Service Bulletin

Reference #053

Automotive Quench Blasthead Modification

The following drawing illustrates the installation of this stiffener plate. (Reference Glasstech drawing number A-0360E40Z2003C)

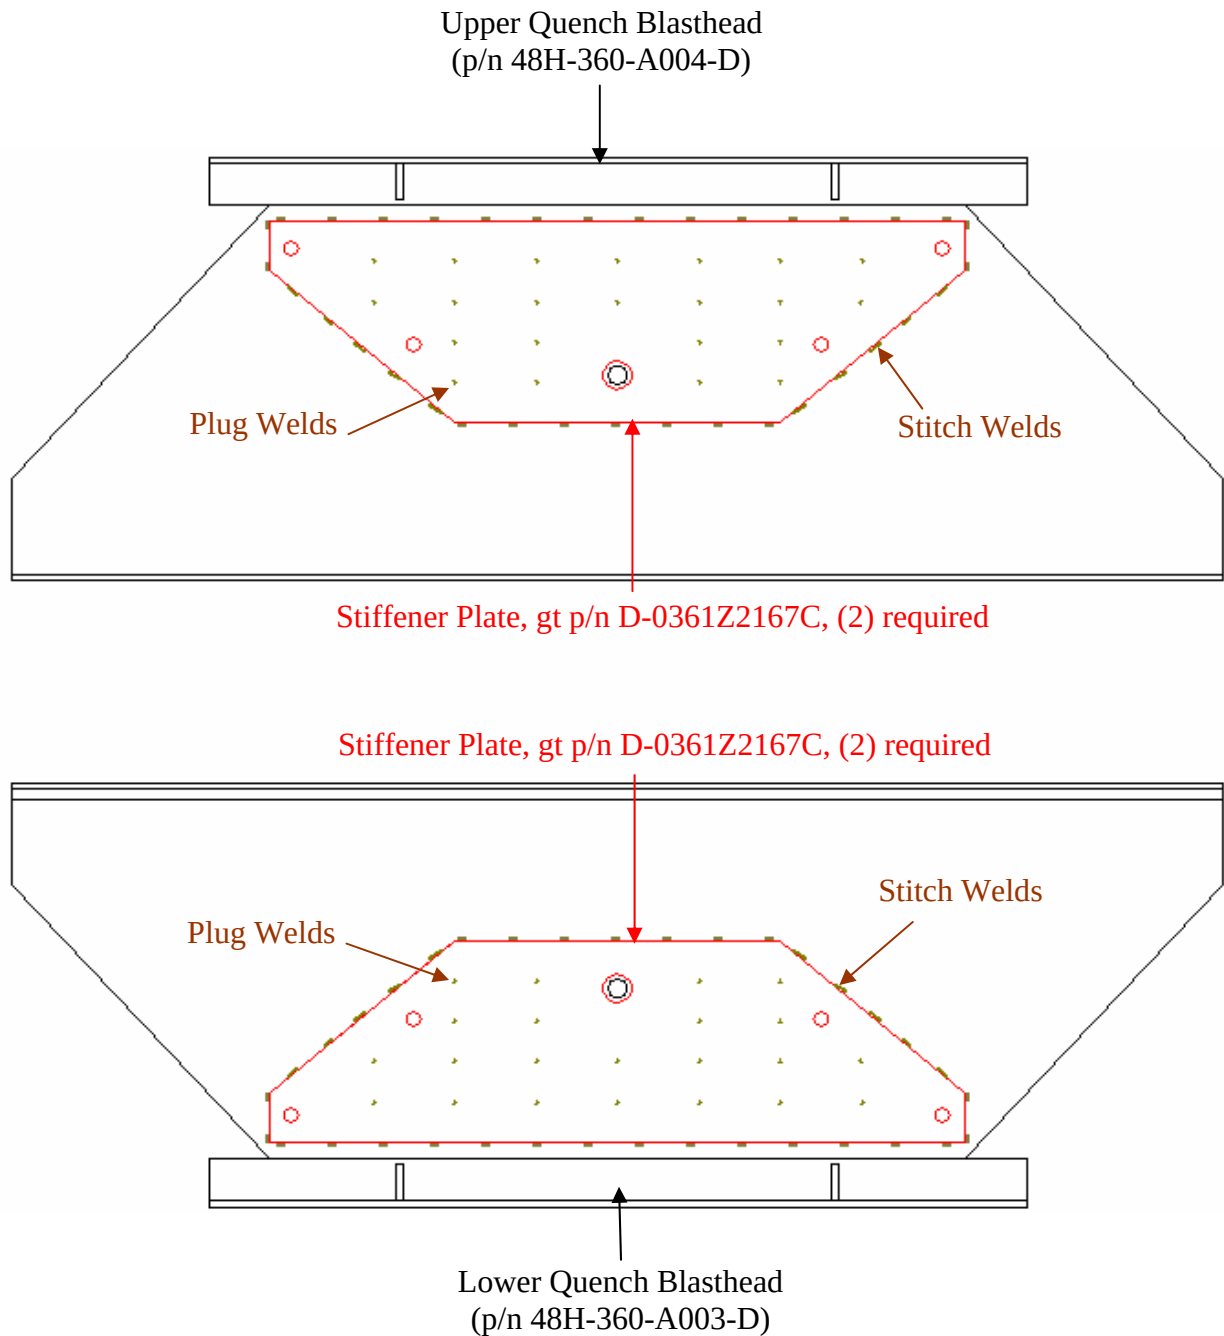
The current design of your quench heads may allow them to be prone to a fatigue problem with the endplates on the outboard surface of the head, causing them to develop cracks. This problem is limited to the outside faces of the outside fins and is not present on other interior fins of the heads.

There is a triangular area of the outside of the quench fin that is currently free to "oilcan" as the head pressurizes and de-pressurizes. Glasstech has designed a stiffening plate (Glasstech part number D-0361Z2167C) that can be welded onto the faces of the existing heads. These plates can be fabricated using the following detail drawing (D-0361Z2167C) or and be provided by Glasstech by contacting Glasstech Customer Service. These plates are intended to be installed on both front and back sides of both upper and lower quench heads. If you have any questions please do not hesitate to contact Glasstech.

1. One (1) inch stitch weld on four (4) inch centers around the entire parameter of the plate.
2. Twenty two (22) plug welds (per plate) are also required.
3. For preparing the surface for welding the stiffener plate, hold the plate on the side of the quench blasthead and mark the areas to be welded. Remove the plate then remove the paint for the weld locations. After the plate has been welded in place repaint the affected areas.
